Our ref: XA/2025/100428/03
Alt Ref: ENVPAC/1/NIT/00019
Your Ref: EN010159

Date: 03 December 2025

ONE EARTH SOLAR FARM

RESPONSE TO EXAMINING AUTHORITY'S WRITTEN QUESTIONS 3

Figure 1. Peak design event (1 in 100 year plus 39% climate change) water level for the River Trent in the vicinity of the proposed development. Water levels are shown in metres Above Ordnance Datum (mAOD). Levels are taken from the Tidal Trent hydraulic model (Jacobs, 2023)

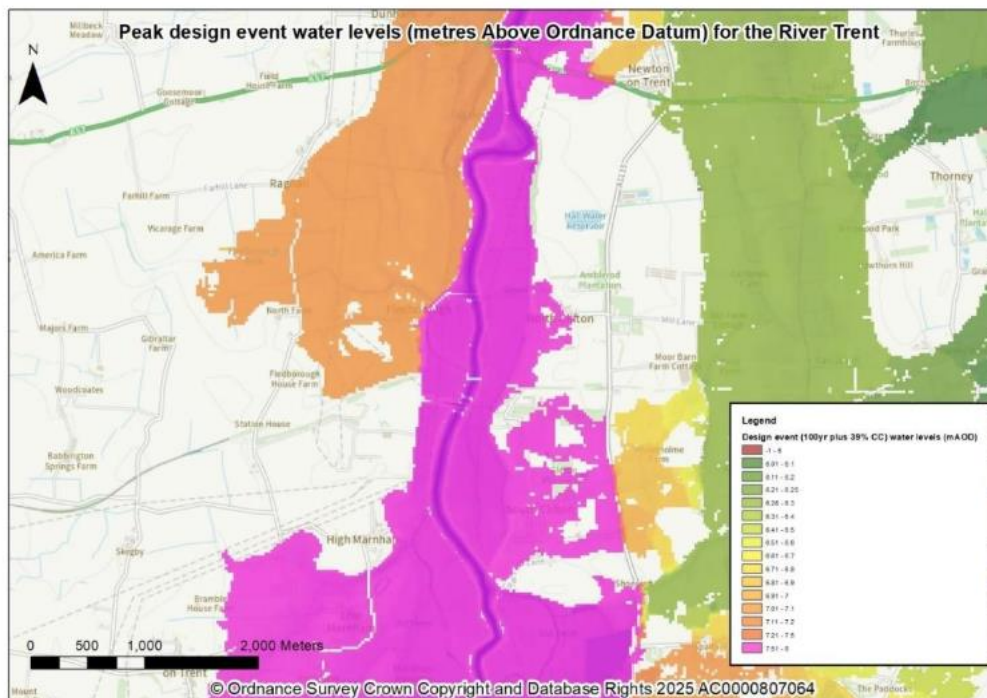
In terms of assessing the impact of the solar panel support frames the applicant's volumetric assessment divides the floodplain up into eastern and western floodplains rather than combining the two estimated levels of 2.2mm and 3.5mm to give 5.7mm. The EA consider this approach reasonable as outlined in our response to documents submitted at deadline 4 dated 12 November 2025 (document library reference:

REP5-082) given the difference in timing of inundation and maximum water levels between the eastern and western floodplains. These two floodplains act independently as illustrated by the maps in figure 1 and 2 below which show the maximum flood level and timing for when maximum flood levels are reached during the design flood event in the vicinity of the proposed development. Water levels on the eastern Trent floodplain reach their maximum earlier than water levels on the western Trent floodplain in the design event. On the eastern floodplain water levels reach their maximum between 82 and 116 hours into the design event simulation and reach a peak level of between 6.2 and 6.9 metres Above Ordnance Datum (mAOD). On the western floodplain maximum levels are reached at around 127 hours and reach a peak level of just over 7 mAOD.

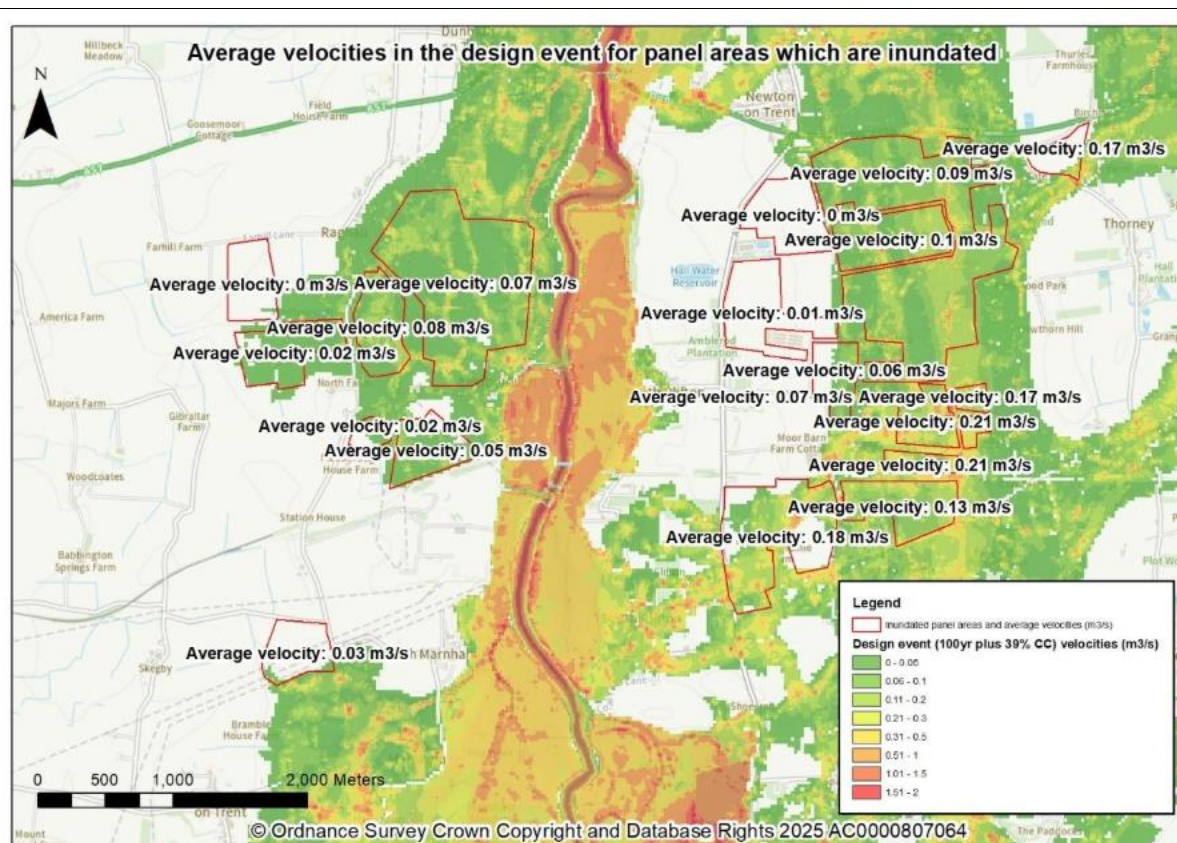
In some cases, panel frames can pose a blockage risk and impede flood flows, however, in the case of One Earth Solar farm the solar panel areas only start to become inundated in the 1% (1 in 100) annual exceedance probability plus climate change scenarios and the respective peak velocities in the panel areas are low generally being around 0.1 metres per second or less (figure 3). On this basis we do not believe blockage risk is a significant issue for this development. Flow velocities are higher in the area of functional floodplain for the River Trent which is defined as the 3.3% (1 in 30 year) extent and where recent historical floods have been observed such as flooding in November 2000, February 2020 (Storm Dennis), October 2023 (Storm Babet) and January 2024 (Storm Henk) although the applicant does not propose any development in these areas.

Figure 4: Slope in degrees in the vicinity of the proposed development based of 1 metre horizontal resolution Light Detection and Ranging (Lidar) data dated 2022

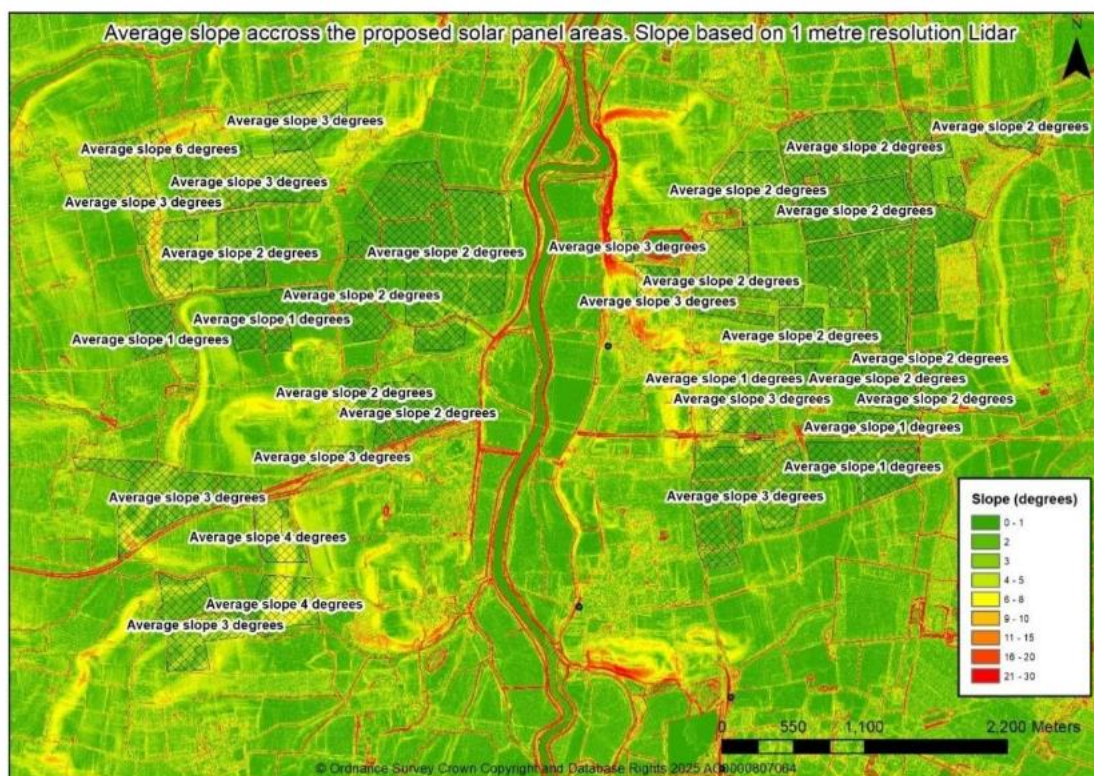
that in some cases vegetation cover alone may not be sufficient for storm water management, particularly in areas most prone to runoff generation in undisturbed conditions and where slopes are steep and soil drainage is poor. In the case of the proposed One Earth Development the slope for where solar panels are proposed is shallow, generally being in the range of 1 to 4 degrees (figure 4) although we note some isolated panel areas where slope is higher (5 to 10 degrees), for example an area of around 3 hectares just to the south west of Hall Water Reservoir at grid reference 482465, 372625. Given the relatively shallow gradient for the areas where the solar panels are proposed we would expect surface water runoff velocities to be low as well as any associated soil erosion and sediment load. The Risk of Flooding from Surface Water with climate change speed dataset also indicates low velocities across the study area (Environment Agency, 2025a). We appreciate that this is a qualitative assessment rather than a quantitative assessment based on detailed direct rainfall (rain on grid) hydraulic modelling with the solar panels in place, but in the context of runoff and soil erosion, such modelling is not typically undertaken in planning applications for solar farms within England.

Figure 1: Extent of the 3.3% (1 in 30) and 1% (1 in 100) AEP scenarios with respect to the red line boundary and proposed development.

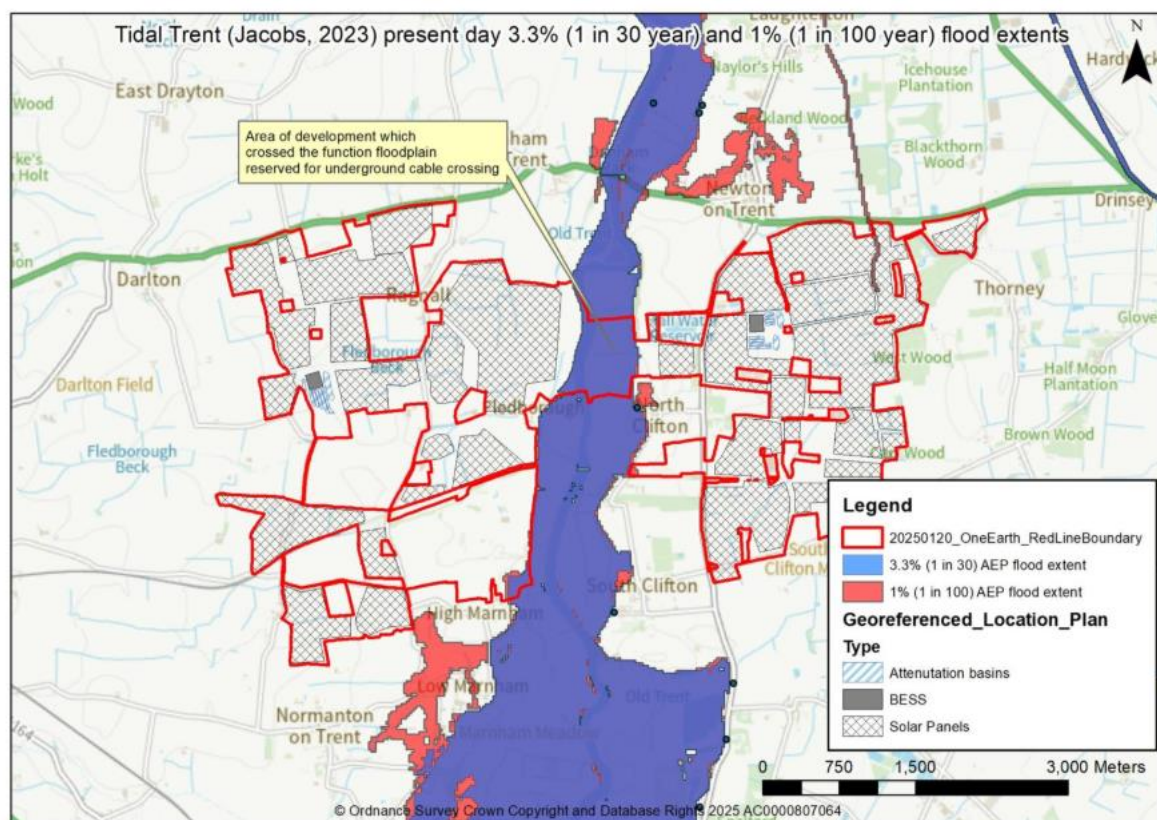
It is our understanding that no part of the built development is within functional floodplain (Flood Zone 3b) and that there is no loss of storage within the functional floodplain. The only aspect of the development that is in functional floodplain is the cable crossing although this is below ground. The map in figure 1 below shows the extent of the present day 3.3% (1 in 30 year) annual exceedance probability event (AEP) and 1% (1 in 100 year) AEP floods from hydraulic modelling of the Tidal Trent (Jacobs, 2023) with respect to the red line boundary and proposed aspects of the development which we have digitised from the works key plan drawing (doc reference number EN-1-159/APP/2.3.2 Rev 03 dated 10th November 2025 examination library reference REP5-005). The 3.3% (1 in 30 year) extent represents the functional floodplain as defined within Table 1 of the Planning Practise guidance ([Flood risk and coastal change - GOV.UK](#)). Additionally, we have included the 1% (1 in 100 year) AEP present day extent as this is a reasonable proxy for what the present-day functional floodplain (3.3% (1 in 30 year) extent might look like based on a higher central climate change allowance of +39% for the 2080s epoch (please see the additional notes section below for calculated peak flows for different AEP scenarios).

Figure 1 shows there will be no built footprint within the 1 in 30yrs flood event (FZ3b) and the 1 in 100yrs flood event (proxy for FZ3b +CC). This shows that there will be no loss of floodplain storage or impediment of flow routes in the functional floodplain. The policy cannot be split into two separate aspects as the highlighted section will only need to be assessed if there is development within the FZ3b or FZ3b + an allowance for climate change which there isn't. In conclusion, the applicant has not placed any development within FZ3b so we feel this part of policy has been satisfied.
